HEARING DATE: April 16, 2026

CASE NO.: Historic Design Review Case No. HIS26-05

APPLICATION SUMMARY: A proposal to extend the front porch on the house located at 625 Church Street SE.

LOCATION: 625 Church St. SE

FRONT ELEVATION

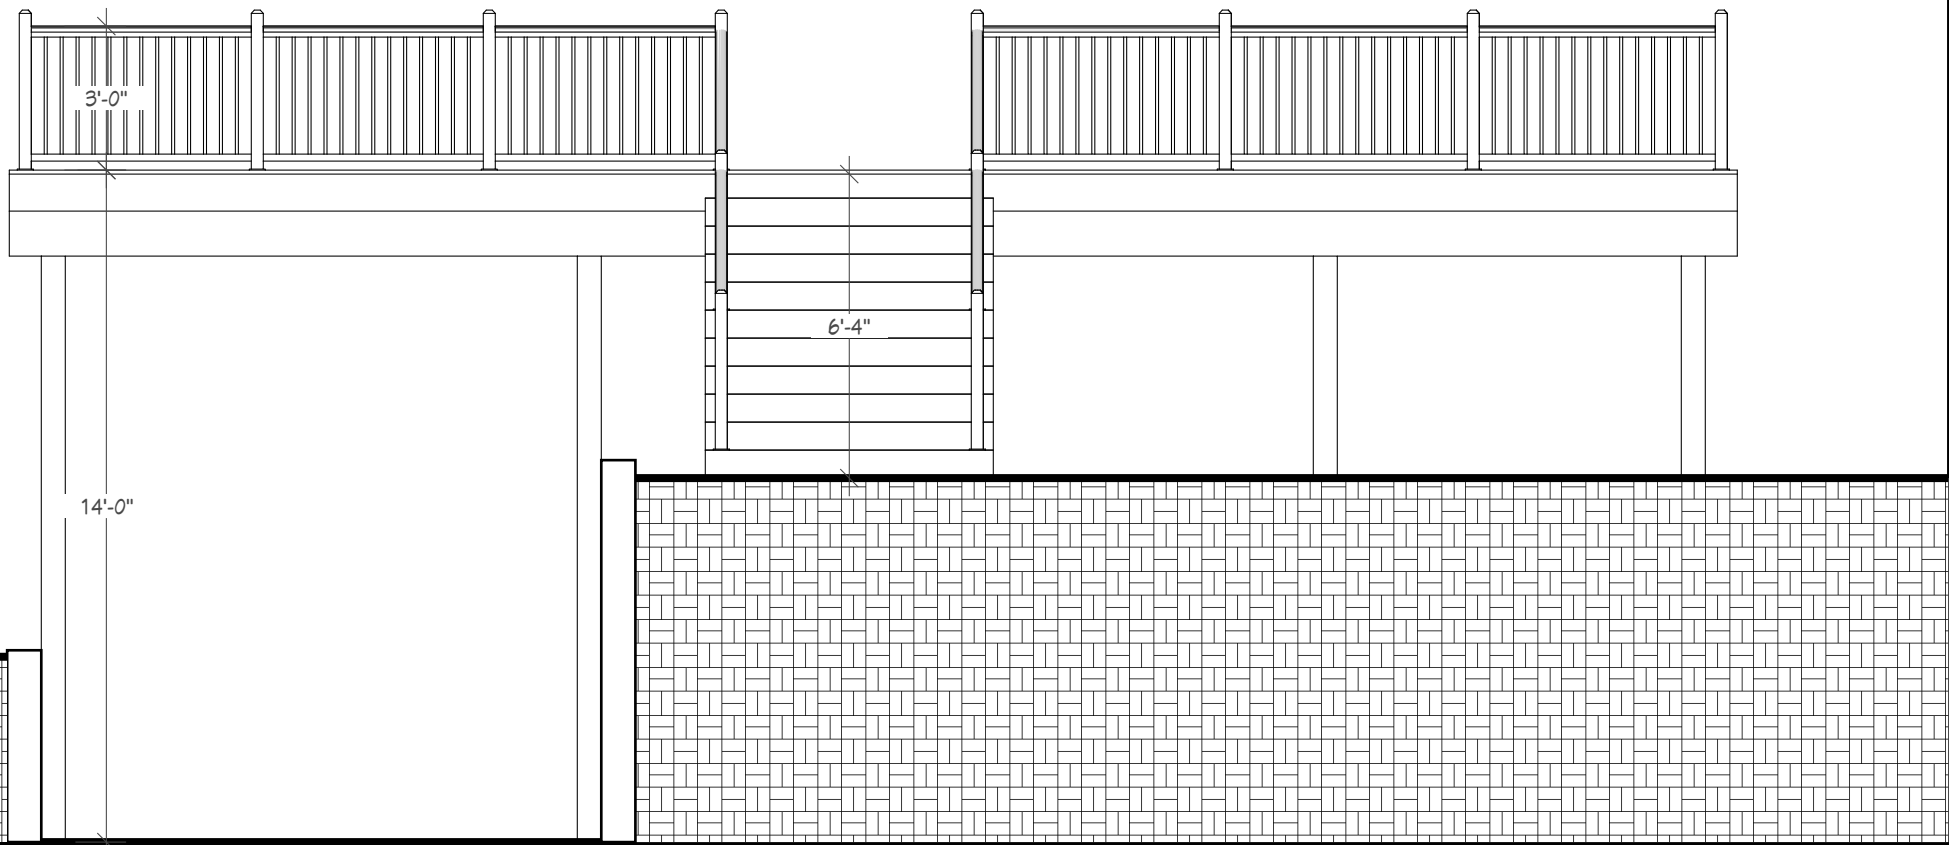
Findings: While the proposal will involve the significant expansion of the existing porch, resulting in this feature extending 5' 5" in front of the existing projecting bay of the resource, this alteration is removable, does not include a porch roof and will not obscure the projecting bay, which is the most distinctive stylistic feature currently associated with the historic character of the house. Staff recommends that the HLC find that 230.065(c) has been met for this portion of the proposal.

Findings: While the proposal will result in the extension of the porch flooring in front of the existing projecting bay of the resource, this alteration is removable, does not include a porch roof and will not obscure the distinguishing character defining features of the central projecting bay, thereby minimizing impacts to the resource. In order to ensure that the proposed new flooring and balustrade are compatible in design and to ensure the proposal better meets this Guideline, staff recommends the HLC approve the proposal with the following conditions:

The new deck that is proposed for 625 Church St. SE does not “minimize” changes to the house.³ Indeed, it could be said to “maximize” changes. The proposal changes the entire primary façade in significant ways. First, two relatively small balconies would be enlarged and joined across nearly the entire façade of the house. Second, the new deck would reach 12 feet into the front yard. The new deck would occupy approximately 400 square feet⁴ more than the existing non-historic balconies. It would be at least twice the size of the existing balconies. It would create what is in effect a carport in front of the non-historic garage. The proposed deck would be a significant and substantial alteration of the primary façade of this contributing house and should not be approved.

Condition 1: The applicant shall paint the entire porch assembly to match the existing porch.

Condition 2: The applicant shall construct the porch balustrade to match the existing in both design and materials.
